COMMUNITY TRANSIT
EXPANSION & REMODEL
MILBANK, SOUTH DAKOTA

ADDENDUM NO 1

Entry / Sloop Foundation Design Detail

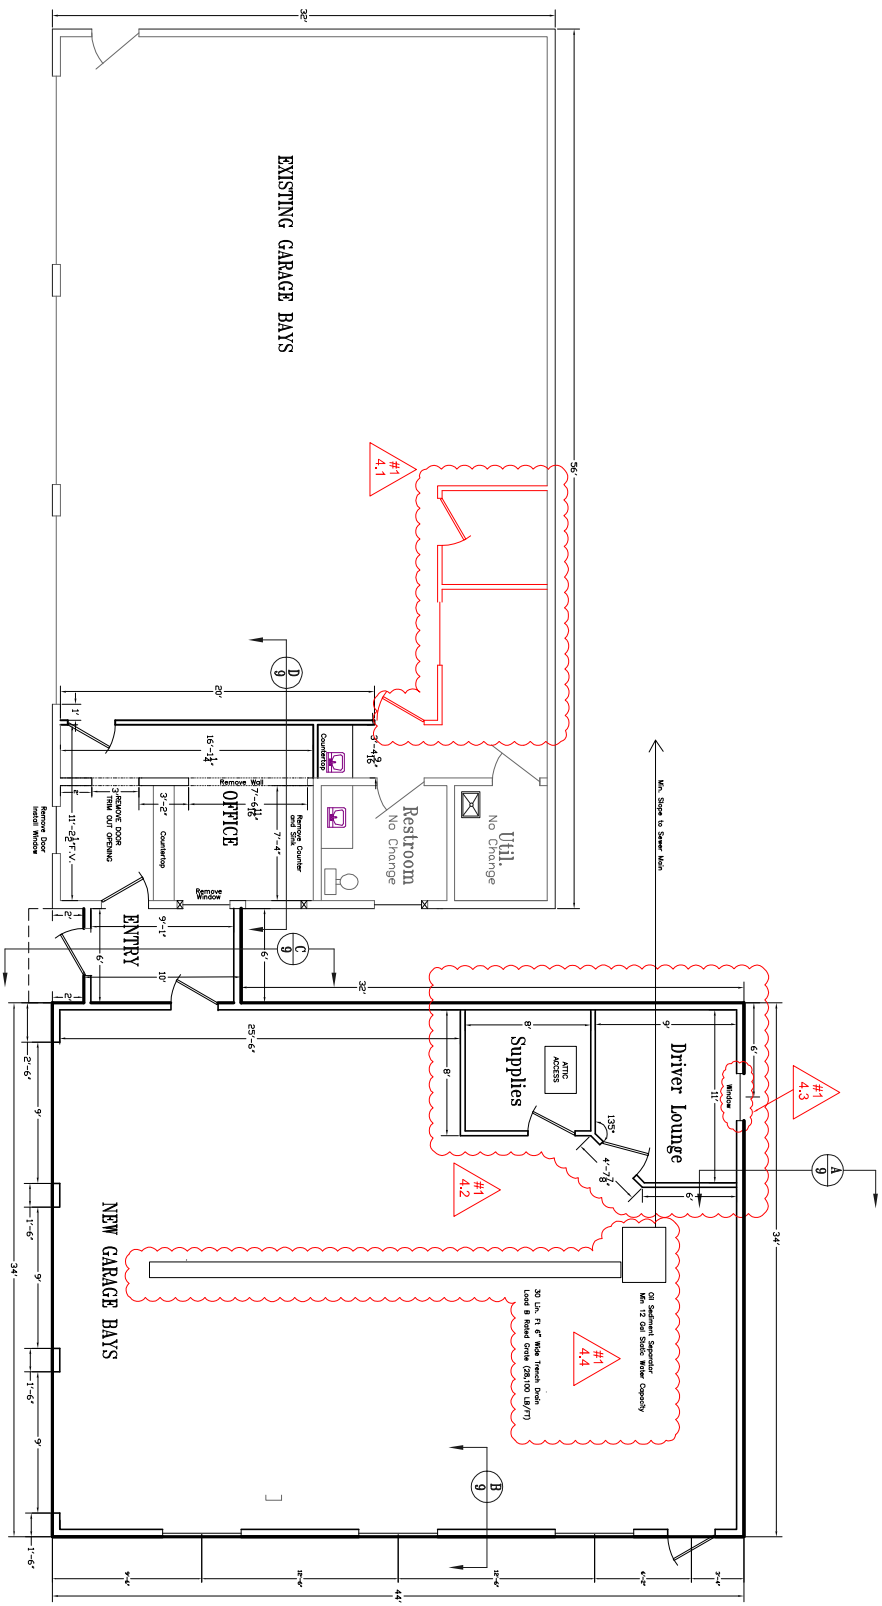
- 1) CHANGE DESIGN OF STOOP AND FOUNDATION WITHIN THE BREEZEWAY BETWEEN BUILDINGS
- 2) NOTE INSIDE NEW GARAGE BAYS FLOOR DESIGN, SHALL CONSIST OF 8" SAND, #4 REBAR 24" O.C.E.W., AND 6" THICK 4000 PSI CONCRETE

- 1). ENGINEER'S PRELIMINARY ESTIMATE FOR BASE BID IS PROJECTED TO BE \$280,000.
- 2). DUE TO CONCERN OF PROXIMITY TO EXISTING POST FRAME CONSTRUCTION, FOUNDATION FOR ENTRY IS RE-DESIGNED TO LIMIT EXCAVATION ADJACENT TO EXISTING STRUCTURE - SEE REVISED PAGE 3 AND 9
- 3). ACCEPTABLE ALTERNATE FOUNDATION DESIGN OF CONVENTUALLY POURED CONCRETE WALL WITH 2" EXTRUDED POLYSTYRENE RIGID FOAM INSULATION ON THE INTERIOR SIDE OF FOUNDATION WALL.
- 4). POLY VAPOR BARRIER IS NOT REQUIRED UNDER THE CONCRETE SLAB.

FLOOR PLAN
COMMUNITY TRANSIT BUILDING - MILWAUKEE
HOLTON ENGINEERING, INC.
 128 E. HICKORY ST.
 SEASON, SD 57056-2906
 (605) 272-2776
REVISED 2/20/24

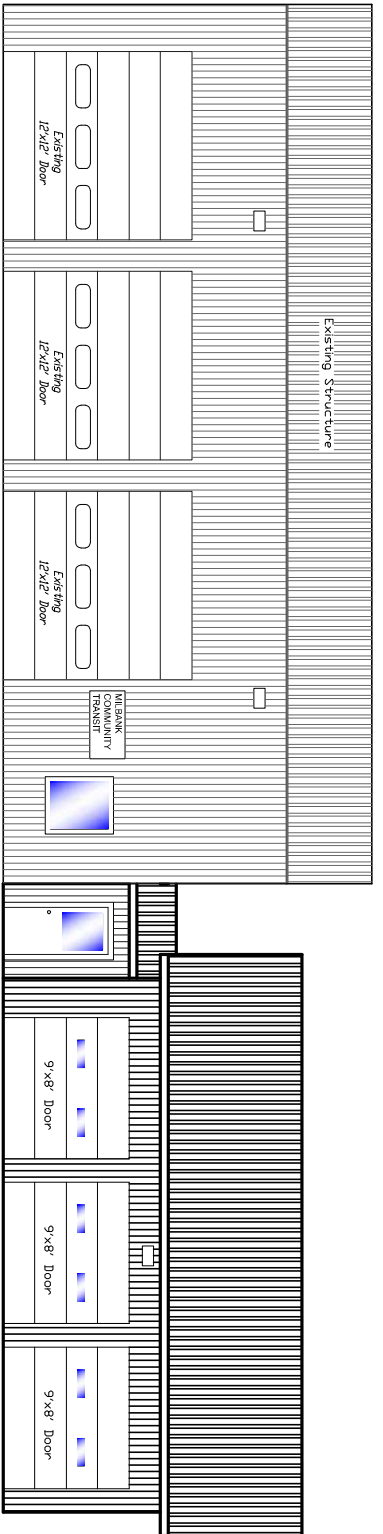
- 1) REMOVE SUPPLIES AND DRIVERS LOUNGE FROM EXISTING GARAGE. NOTE: COUNTERTOP AND SINK TO REMAIN.
- 2) ADD SUPPLIES AND DRIVERS LOUNGE WITHIN THE NEW GARAGE BAYS
- 3) ADD WINDOW IN DRIVERS LOUNGE. - SEE NOTE BELOW FOR SHEET 6
- 4) ADD 6" WIDE TRENCH DRAIN AND OIL & SEDIMENT SEPARATION PIT - SEE SHEET 4 FOR MORE DETAIL

West View

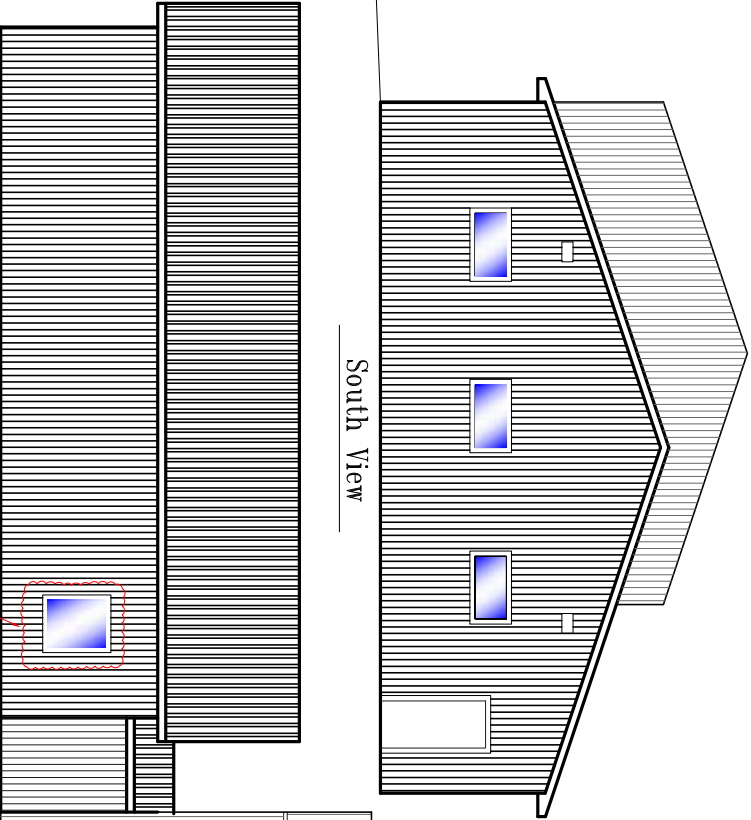
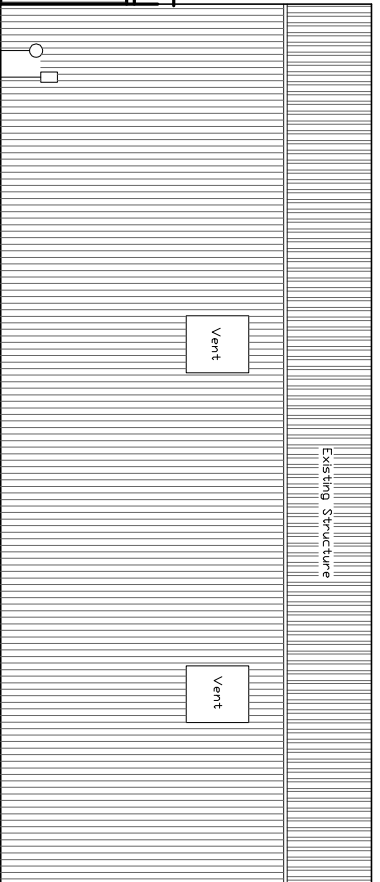
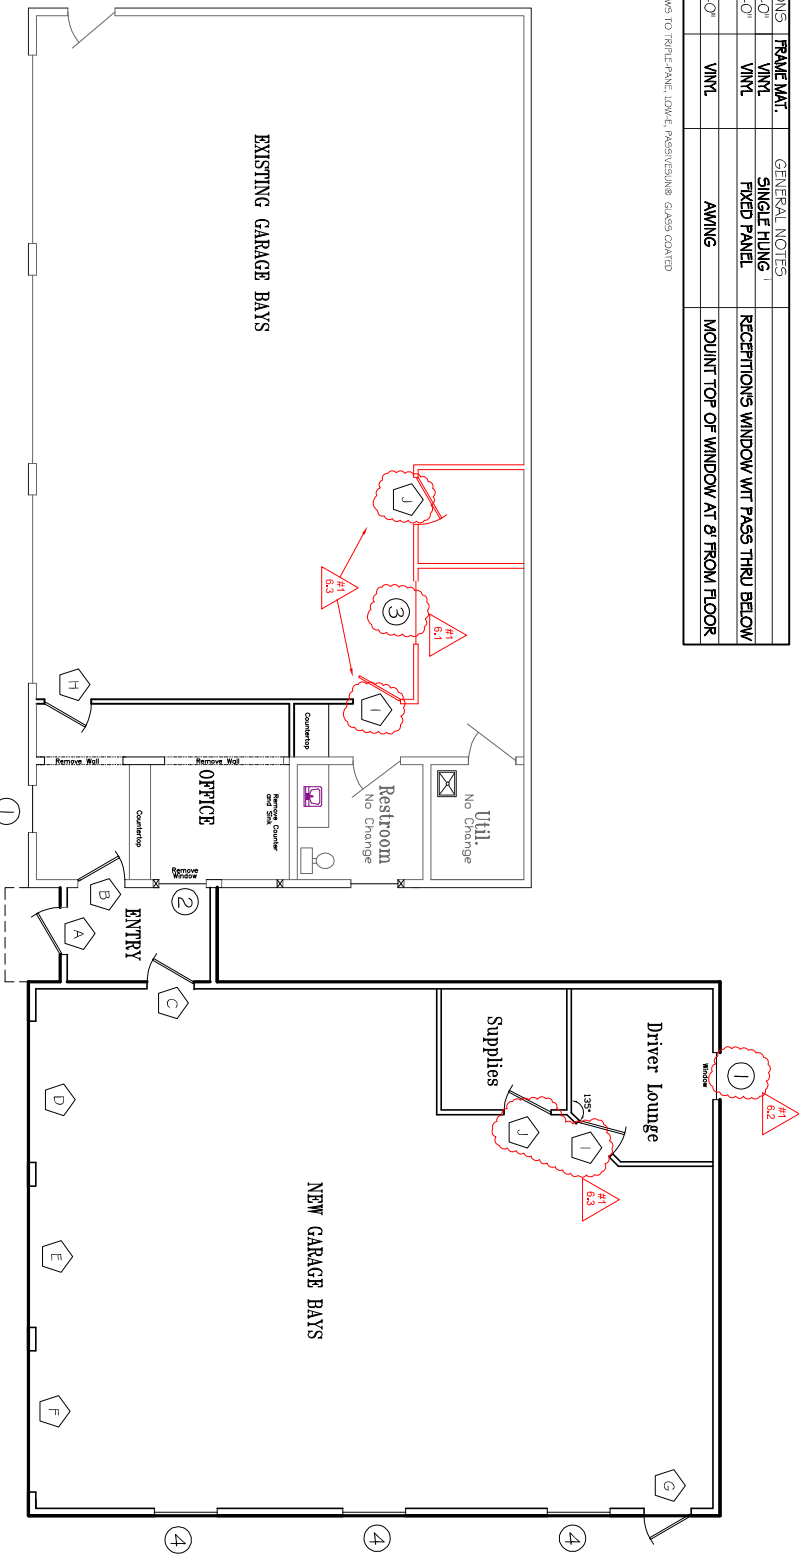
- 1) ADD WINDOW IN DRIVERS LOUNGE. - SEE NOTE BELOW FOR SHEET 6

ELECTRICAL PLAN
COMMUNITY TRANSIT BUILDING - MILBANK
HOLTON ENGINEERING INC
 128 E. HICKORY ST. SEASIDE, ID. PH. 1-409-208-2000
 REVISION 2/20/24

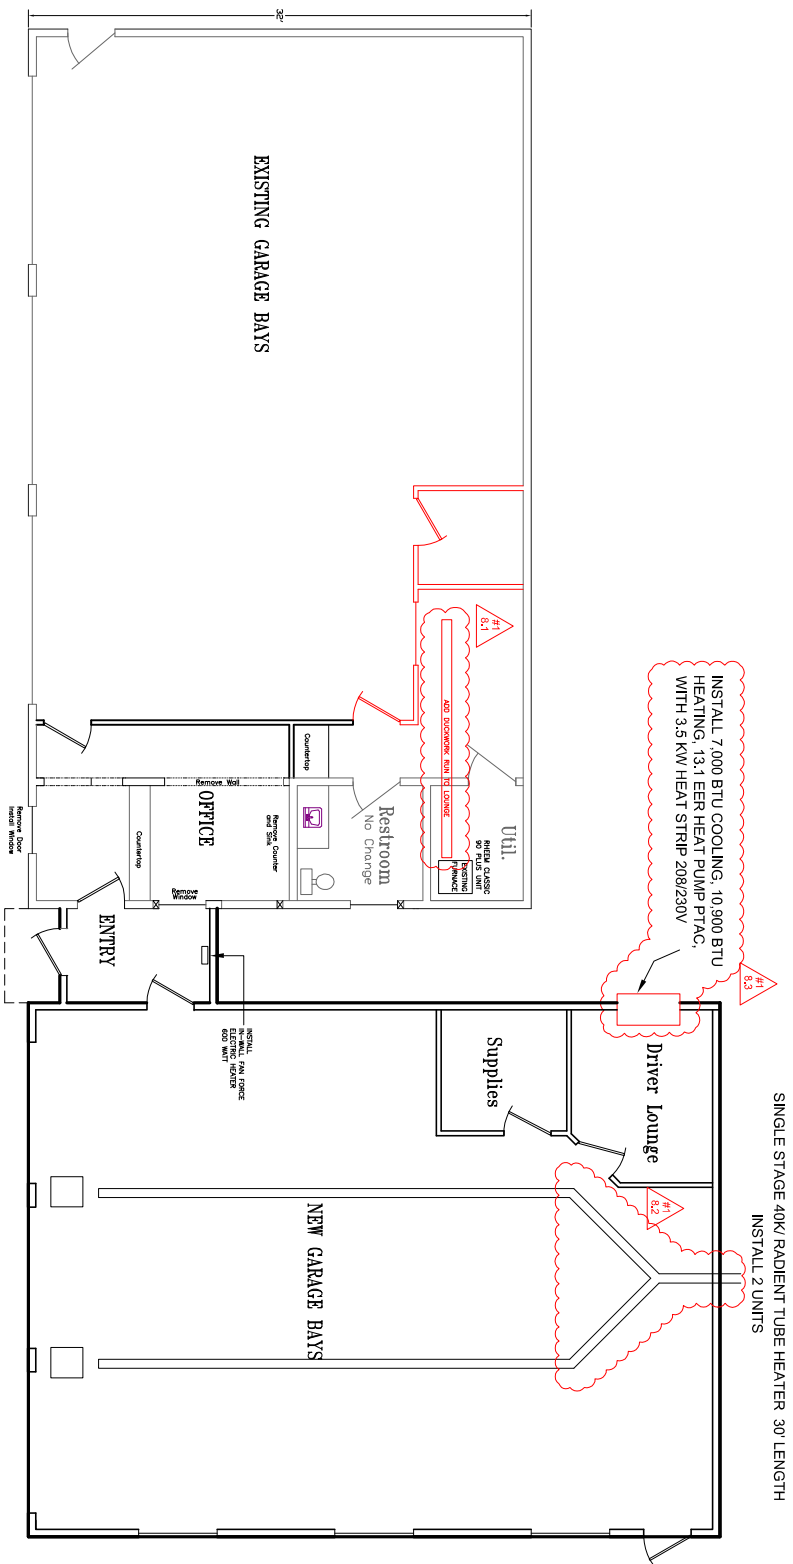
- 1) RELOCATE ELECTRICAL COMPONATES FROM SUPPLIES AND DRIVERS LOUNGE DUE TO THE RELOCATION OF ROOMS
- 2) ADD NOTE THAT EXISTING ELECTRICAL COMPONENTS IN OFFICE AND EXISTING GARAGE WILL BE EFFECT BY THIS REMODEL
- 3) DUE TO CONFLICT WITH RADIANT HEATERS, REDUCE AND MOVE THE NUMBER OF 2x4 LED LIGHTS
- 4) TOTAL ELECTRICAL COMPONENTS ADJUSTMENT:
 - a) ADD 2 QTY 110V RECEPTACLES
 - b) SUBTRACT 4 QTY 1x4 LED LIGHTS
 - c) SUBTRACT 5 2x4 LED LIGHTS

HVAC PLAN
 COMMUNITY TRANSIT BUILDING - MILWAUKEE
 HOLTON ENGINEERING INC
 128 E HICKORY ST
 SEASIDE, WI 53084
 PHONE: 262-527-1500
 FAX: 262-527-1501
 REVISED 2/20/24

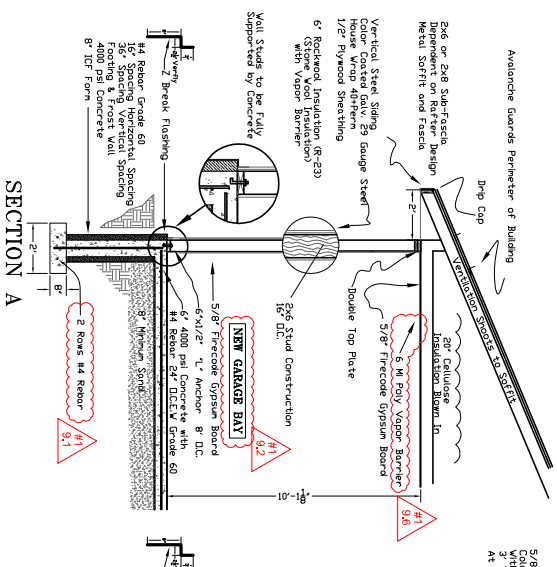
- 1) REMOVE NOTE " ADD DUCTWORK RUN TO LOUNGE"
 - a) THERE IS NO CHANGE TO EXISTING SYSTEMS.
- 2) CHANGE EXHAUST OF RADIANT TUBE HEATERS AWAY FROM LOUNGE WALL.
- 3) ADD NOTE " INSTALL 7,000 BTU COOLING, 10,900 BTU HEATING, 13.1 EER HEAT PUMP PTAC, WITH 3.5 KW HEAT STRIP 208/230V"

SECTION A

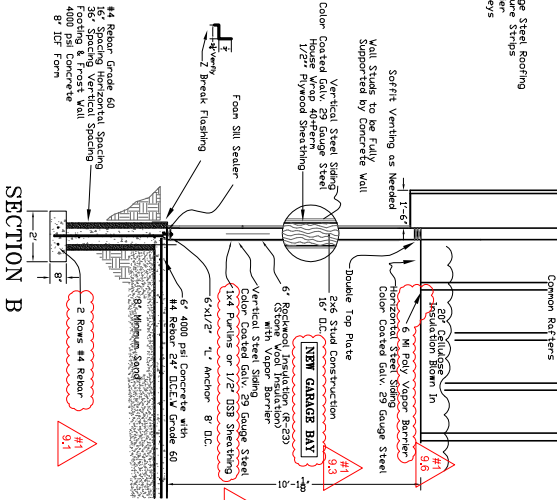
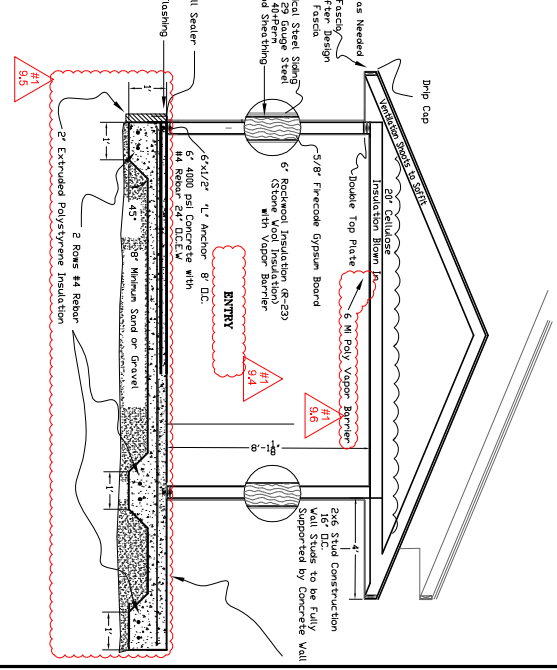
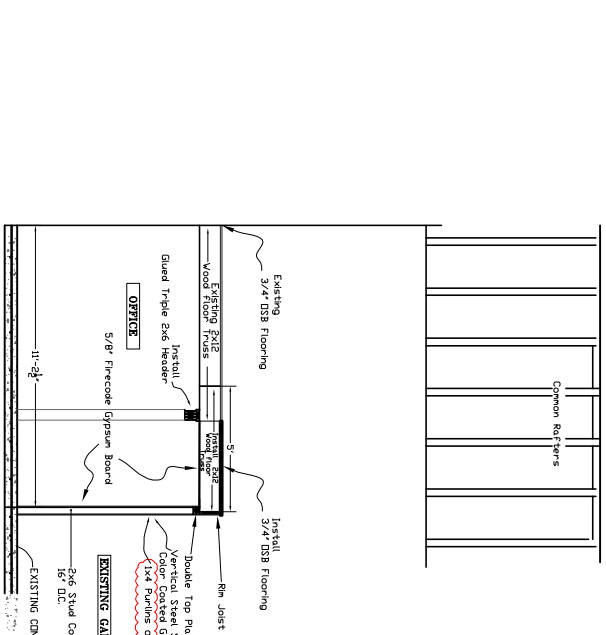
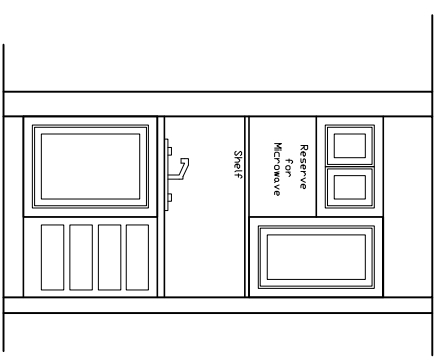
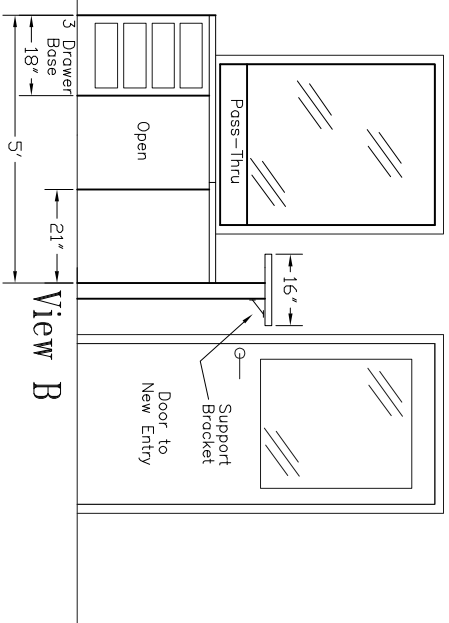
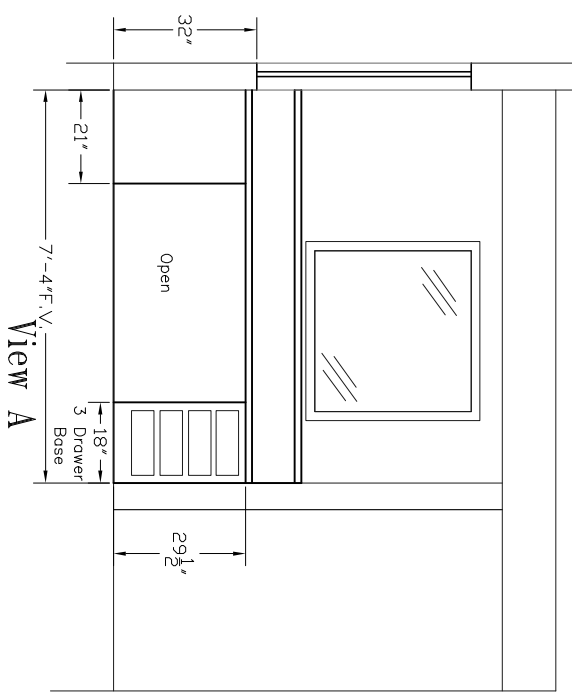
- 1) ADD NOTE " 2 ROWS #4 REBAR"
- 2) CHANGE ROOM LOCATION LABEL FROM LOBBY TO NEW GARAGE BAY
- 3) ADD ROOM LOCATION LABEL OF NEW GARAGE BAY
- 4) CHANGE ROOM LOCATION LABEL FROM BREEZE-WAY TO ENTRY
- 5) SHOW FOUNDATION DESIGN CHANGE ON SECTION 3 TO THICKEN EDGE SLAB.
- 6) ADD NOTE " 6 MIL POLY VAPOR BARRIER" TO BE INSTALLED ON CEILING.
- 7) ADD NOTE " 1x4 PURLIN OR 1/2" OSB SHEATHING" FOR BACKER FOR STEEL LINER
